SERVICE BULLETIN

FUJI HEAVY INDUSTRIES LTD.

NO : FAS-059

1. SUBJECT : Torque Value Change for Main Landing Gear Attaching Bolts.
2. AIRCRAFT AFFECTED: FA-200 Series, Serial Nos. 12 thru 131.
3. PRIORITY : Essential.
4. REASON : To improve reliability of the main landing gears.
5. DESCRIPTION : Change torque value for the main landing gear attaching bolts. Revise the affected pages of Service Manual. (Refer to para. 13-(3) of this Service Bulletin.)
6. ACCOMPLISHMENT : At the first periodic check after receipt of this bulletin.
7. APPROVAL : JCAB Approval (NO-TOKYO-028) June 28, 1971
8. PARTS REQUIRED : The following parts are required to comply with this publication. (Hardware may be reused except for cotter pins.)

Figure 1

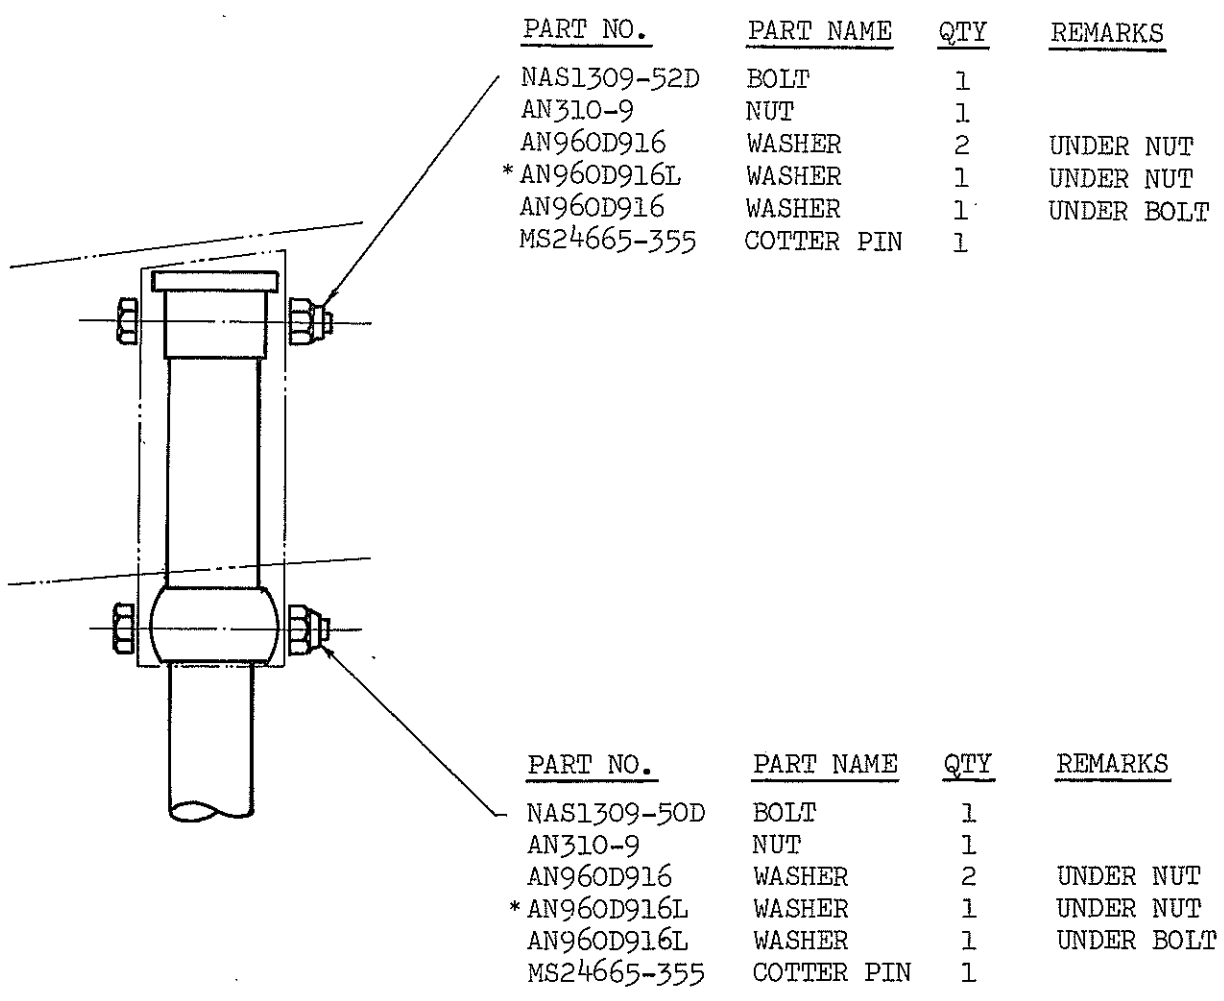
- (1) Raise the airplane in accordance with Service Manual, para. 2-2 (1).
- (2) Remove the two access covers for main landing gear attaching bolts. (No. 17 and 18 covers shown in figure 3-5, Service Manual.)
- (3) Loosen the main landing gear attaching bolts, and re-torque the bolts to 150 to 250 inch-pounds.

The above torque value before revision was 300 \pm 50 in-lbs.
It is requested that the following affected pages of Service Manual be revised accordingly.

- (4) If play exists after tightening, place one washer, AN960D916L, under the nut for adjustment.
- (5) After checking for proper torque, secure the nut with cotter pin.
- (6) Install the removed access covers.
- (7) Lower the airplane and remove the jacks.

- Notes: 1. No play is permitted at a torque of 150 inch-pounds (approx).
 2.*Marked washer to be used for adjustment.
